Value Engineering Study Report

William Few Parkway Extension, Phase 2 STP-7037 (1) P.I. Number 250620 Columbia County

RE: Submittal of the final Value Engineering Report
Project – STP-7073 (1)
Columbia County
P.I. No. – 250620
William Few Parkway Extension Phase 2
PBS&J Project Task Order No. 18

DESCRIPTION: **WIDEN RIVERWOOD PARKWAY AT WILLIAM FEW**
PARKWAY INTERSECTION.

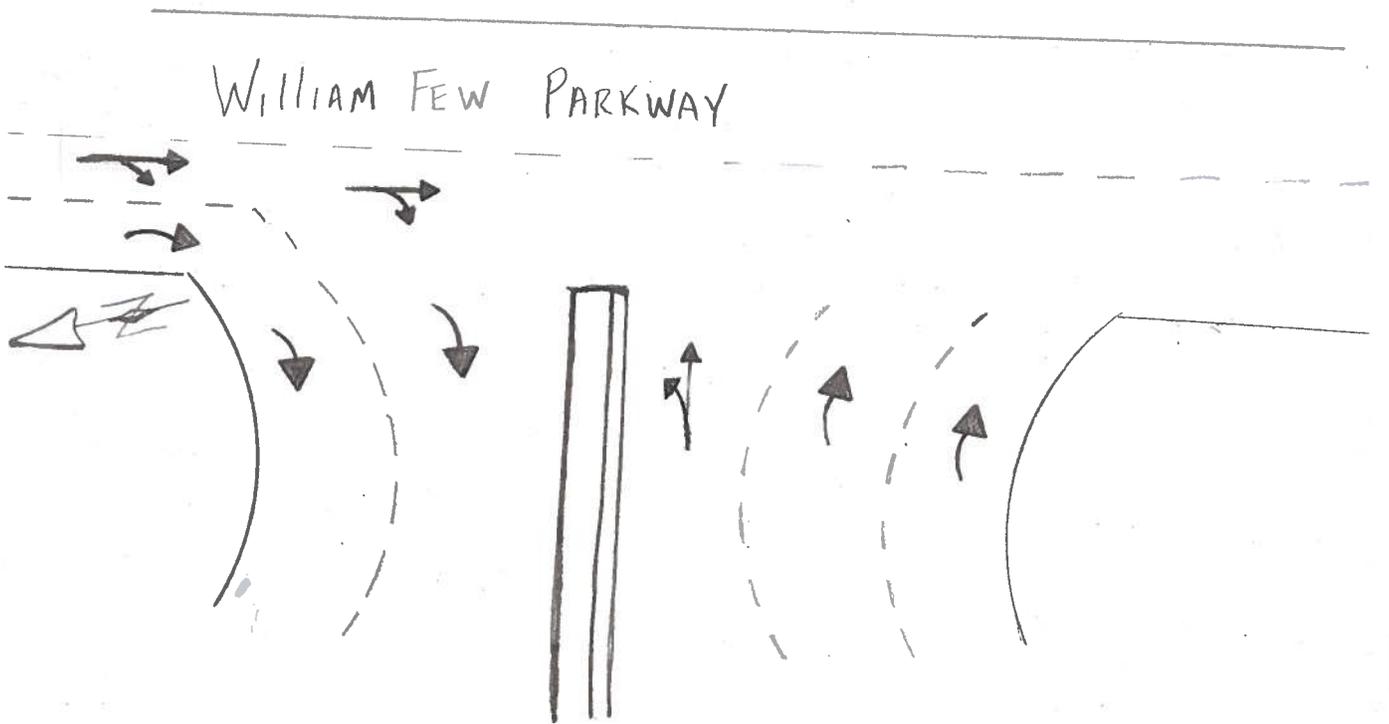
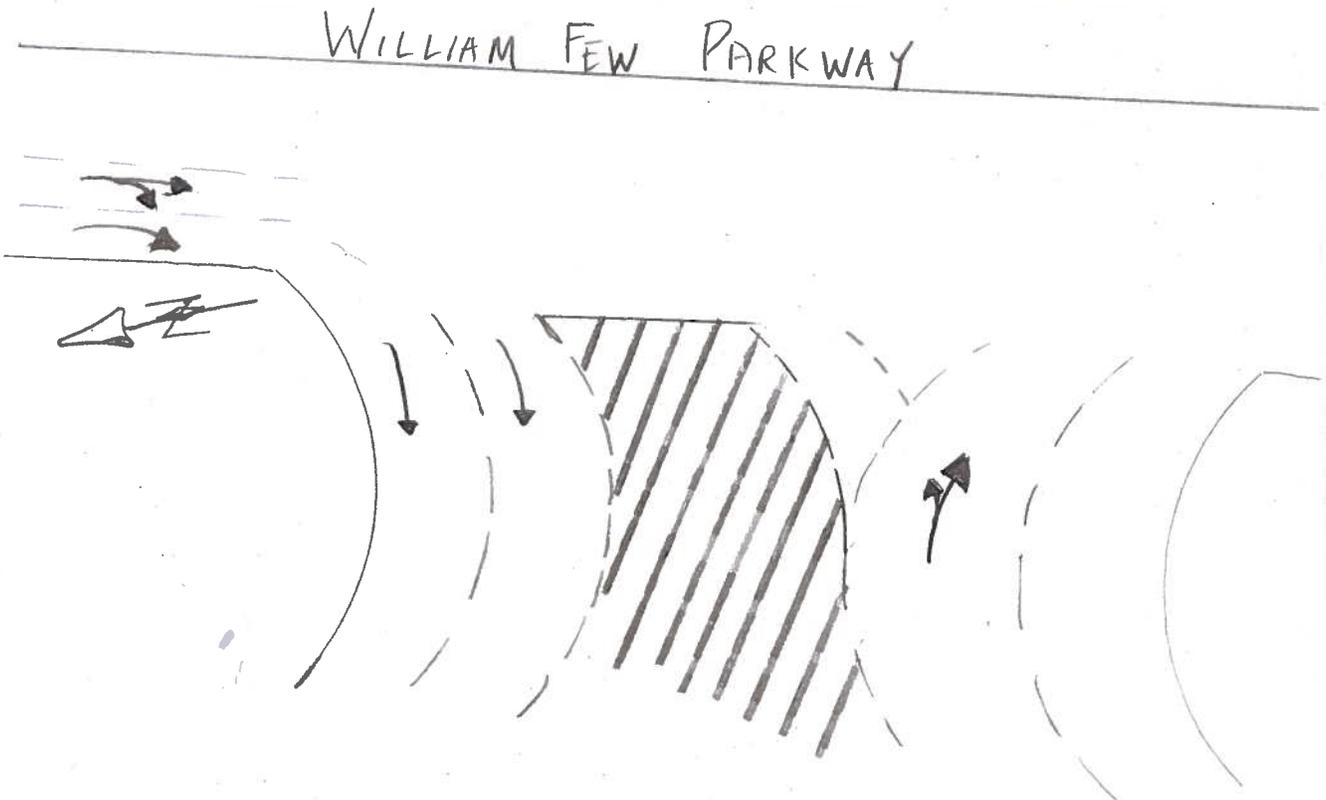
Original design does not allow for widening on Riverwood Parkway to foster improved traffic operations at the William Few Parkway intersection.

Construct additional turn lanes for the entrance for both egress and ingress on Riverwood Parkway to improve traffic operations at the intersection, as well as to remove traffic storage from William Few Parkway and Washington Road.

Additional turn lanes could be constructed on Riverwoods Parkway, as well as on William Few parkway, south of the Riverwoods intersection. The addition of turn lanes would enhance traffic operations at the intersection by allowing more turn movement opportunities in a shorter period of time. The addition of turn lanes in these areas would also relieve traffic storage on Washington Road and the southern portion of William Few Parkway by reducing traffic movement times. Additional widening on Riverwoods Parkway north of the William Few Parkway intersection will likely be required to handle the additional traffic volumes generated by the more efficient traffic operation due to the addition of turn lanes.

DESCRIPTION: **REDUCE THE PAVED SHOULDER TO 7'-6"** SHEET NO.: **1 of 5**

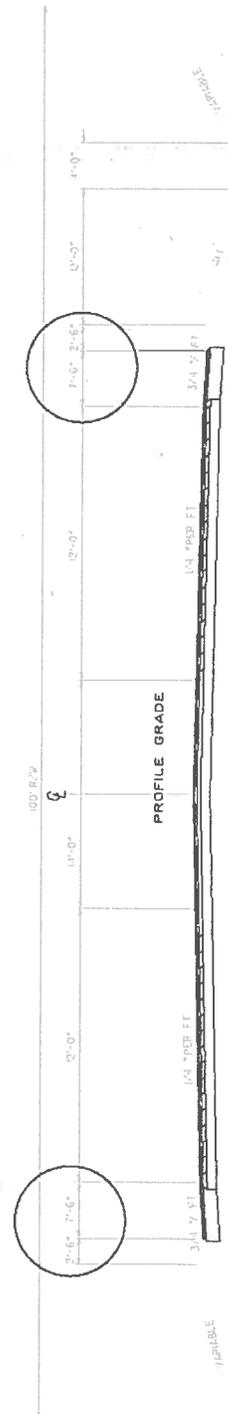
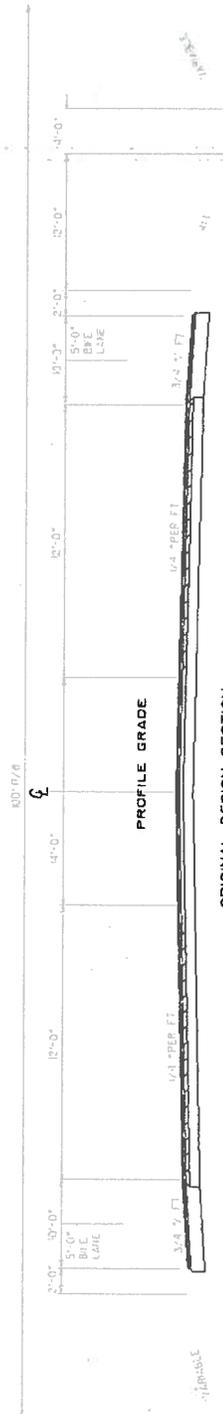
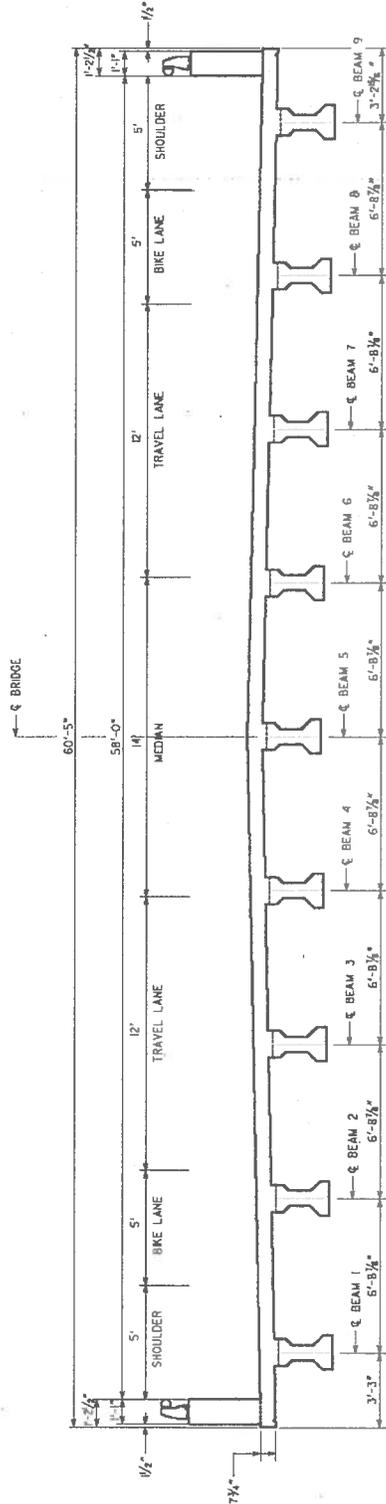
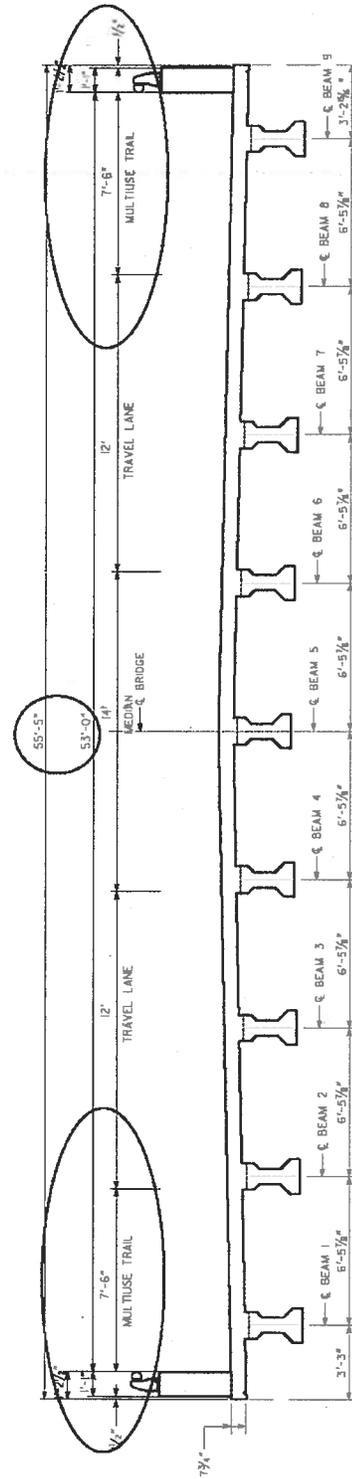
The original roadway design calls for a 12'-0" improved shoulder (10'-0" paved).
 The original bridge design calls for the construction of a 600 ft long bridge over Euchee Creek and is comprised of fifteen 40 ft spans. The bridge is 60'-5" wide and accommodates 2-12 ft travel lanes, a 14 ft flush median, 5 ft flush shoulder and 5 ft bike lanes on each side. The intermediate bents are all pile bents.

The alternative roadway design calls for reducing width of the improved shoulder to 10'-0" (7'-6" paved). The reduced shoulder width is proposed to be carried over the bridge as well. The 7'-6" width serves as a multi-use trail for pedestrian as well as bicycle traffic.

Reduction of the width of travel lanes throughout the project would result in 5' of full build-up pavement that would not have to be constructed, resulting in significant cost savings. The 7'-6" paved shoulder exceeds the minimum required (6'-6" paved) by "GDOT Design Standards for Collector Roadways (Table 6.2/Page 6-3). A 7'-6" would accommodate a 4'-0" Bike Lane and 3'-6" for the construction of rumble strips adjacent to the through lanes.

The reduced bridge cross section would be 55'-5" (a reduction of 5'). All other bridge geometry remains the same as in the current design.

DESCRIPTION: **REDUCE MEDIAN TO 12'-0"** SHEET NO.: **1 of 5**

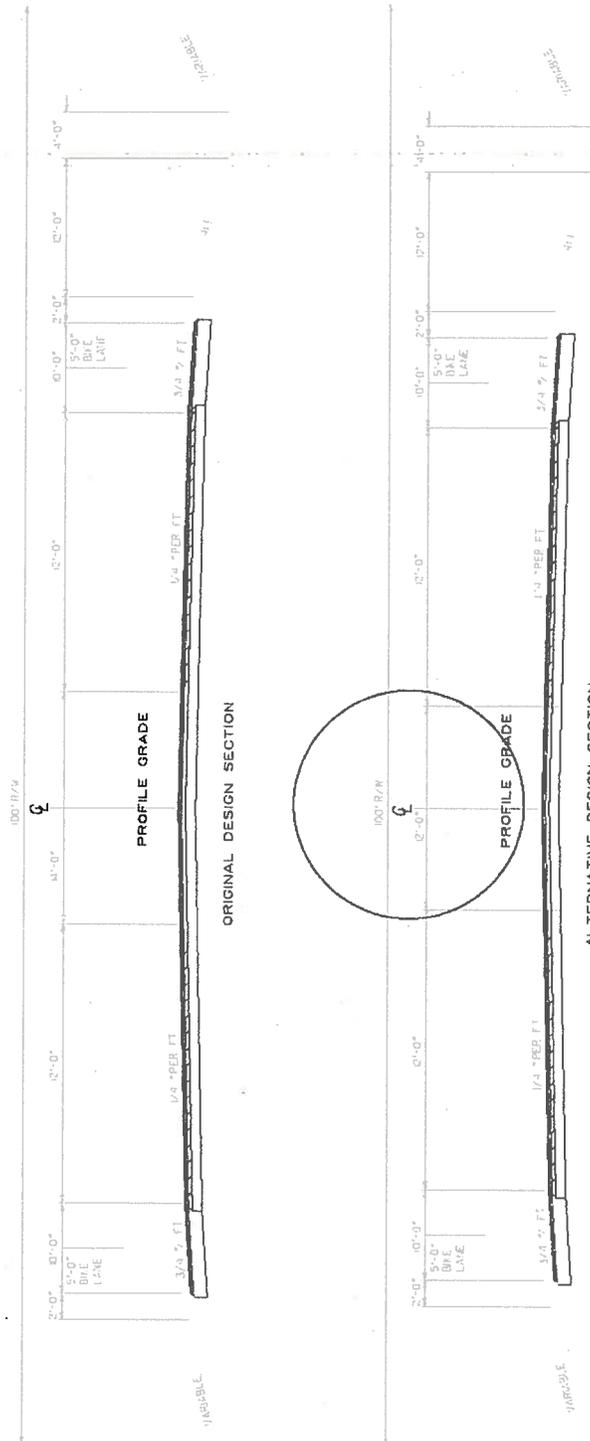
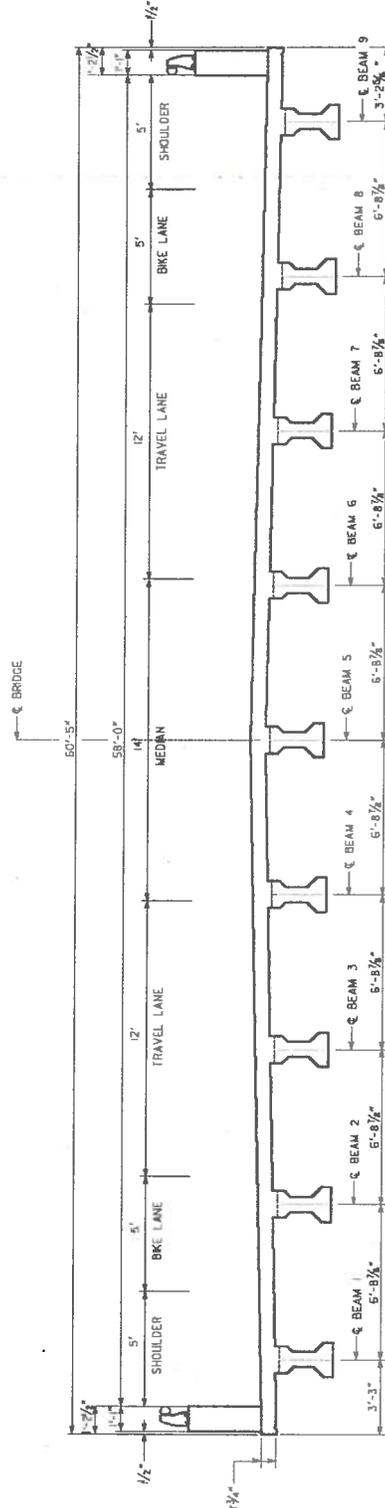
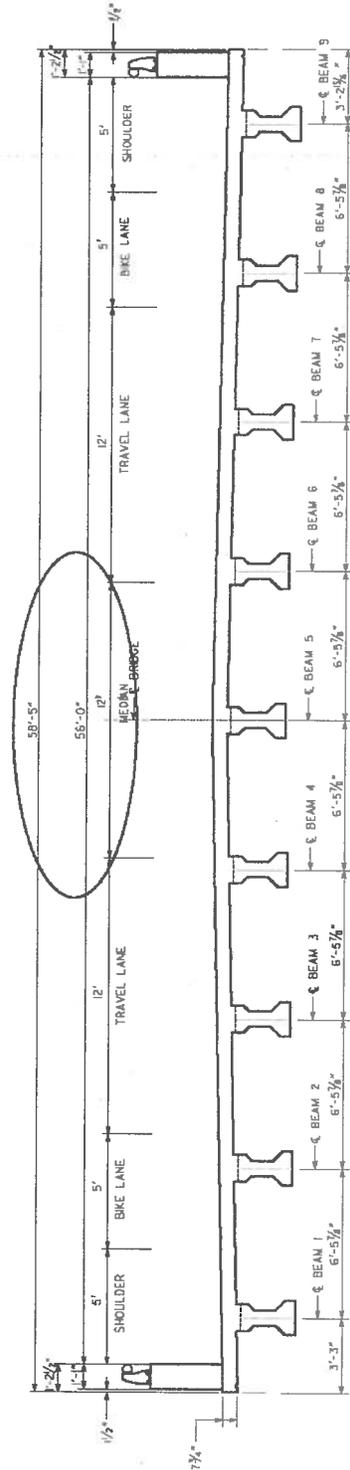
The original design calls for a 14'-0" flush median (two-way left turn lane).

The alternative design calls for reducing the flush median to 12'-0". The reduced median width is proposed to be carried over the bridge as well.

Reduction of width of the flush median throughout the project would result in 2' of full build-up widening that would not have to be constructed, resulting in significant cost savings. Although a 12'-0" flush median would require an exception to GDOT policy, AASHTO's "Policy on Geometric Design of Highways 2004" states that 10'-0" to 16'-0" flush medians are permissible (page 434).

The reduced bridge cross section would be 58'-5" (a reduction of 2'). All other bridge geometry remains the same as in the current design.

DESCRIPTION: **CONSTRUCT A 60' WIDE TWO-LANE BRIDGE WHICH
CAN LATER BE RE-STRIPED AND UTILIZED AS A 4-
LANE BRIDGE.**

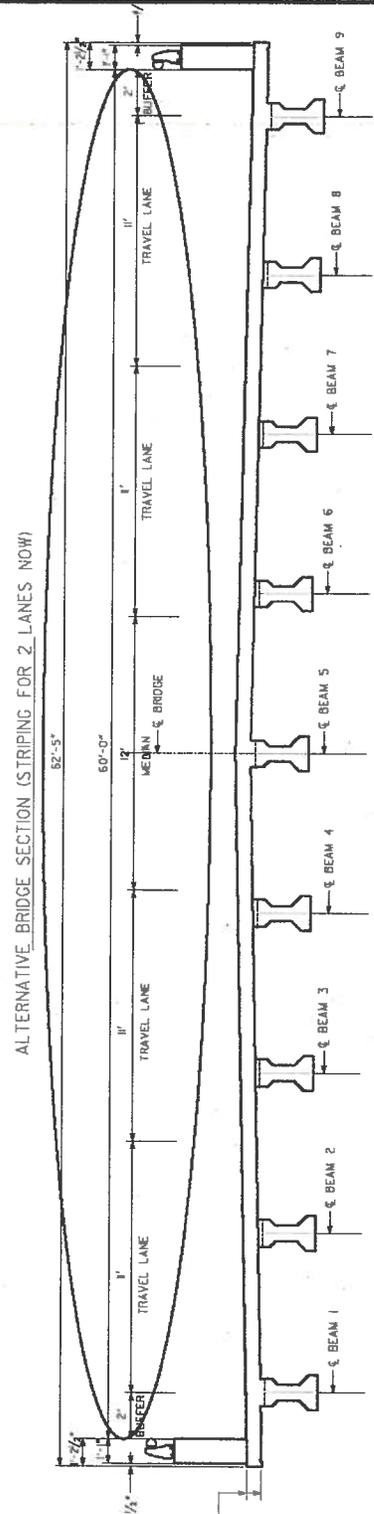
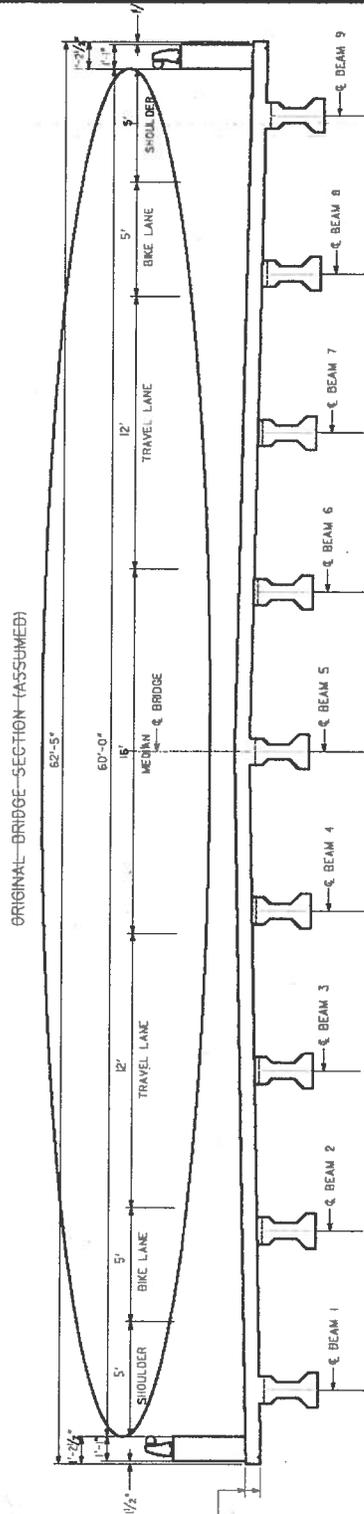
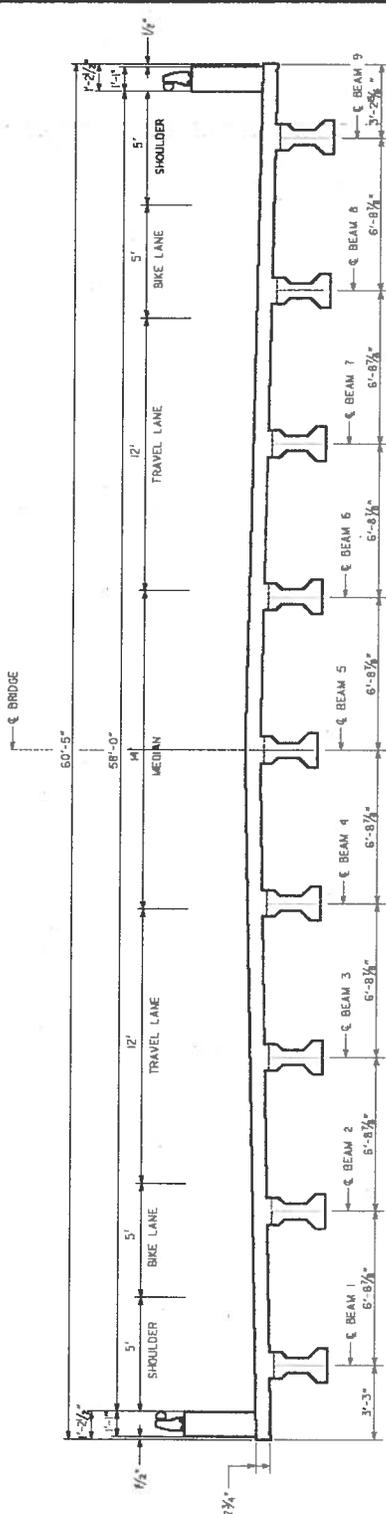
-Original design calls for construction of 58' wide full depth paving consisting of a 14' two-way left turn lane, 2- 12' travel lanes, and 2- 10' paved shoulders.

-Proposed alternate construction calls for 60' wide full depth pavement consisting of a 16' two-way left turn lane, 2-12' travel lanes, and 2- 10' paved shoulders.

The additional full depth build-up is proposed for roadway and bridges to allow for future conversion of this section to a five lane urban section. The future typical section will consist of a 12' two-way left turn lane, 4- 11' travel lanes, as well as a 2.5' curb and gutter section. Proposed and alternate details of each respective typical section are shown on Illustrations for WF-11. This alternate provides a 60' section from face of bridge rail to face of bridge rail for bridge sections to match the 60' typical pavement section proposed for the roadway.

DESCRIPTION: **USE 11'-0" TRAVEL LANES.** SHEET NO.: **1 of 5**

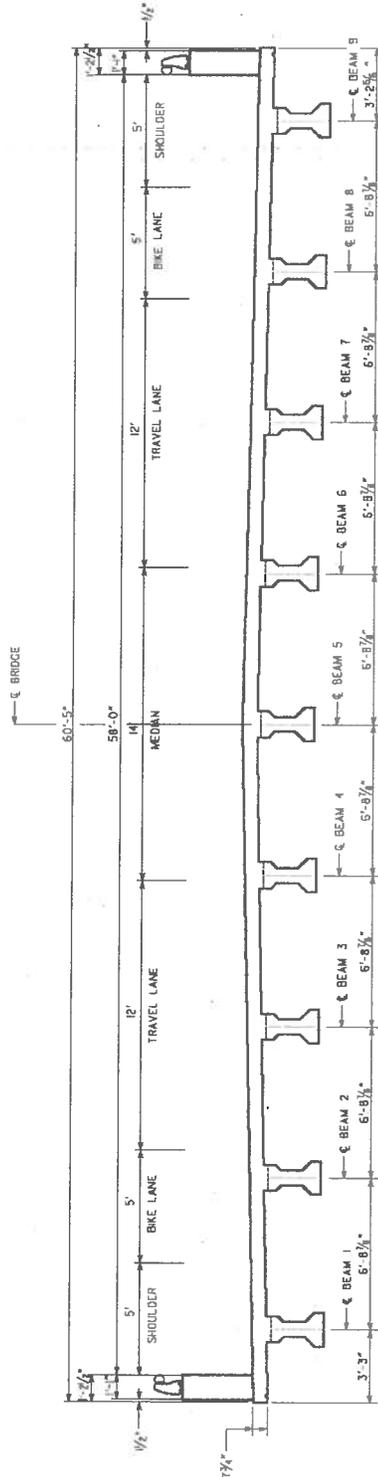
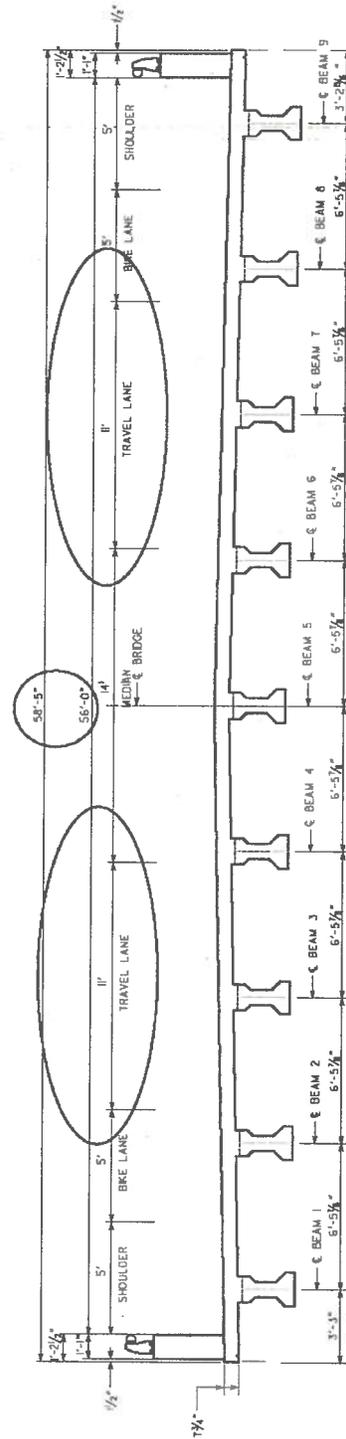
The original design calls for a 12'-0" travel lanes.

The alternative design calls for reducing the travel lanes to 11'-0. The reduced lane width is proposed to be carried over the bridge as well.

Reduction of width of travel lanes throughout the project would result in 2' of full build-up widening that would not have to be constructed, resulting in significant cost savings. Although 11' lanes would require an exception to GDOT policy, AASHTO's "Policy on Geometric Design of Highways 2004" states that 11' lanes are permissible. It also states that under interrupted-flow operating conditions at low speeds (45 mph or less), narrower lanes are normally adequate and have some advantages. (See Pages 472-473).

The reduced bridge cross section would be 58'-5" (a reduction of 2'). All other bridge geometry remains the same as in the current design.
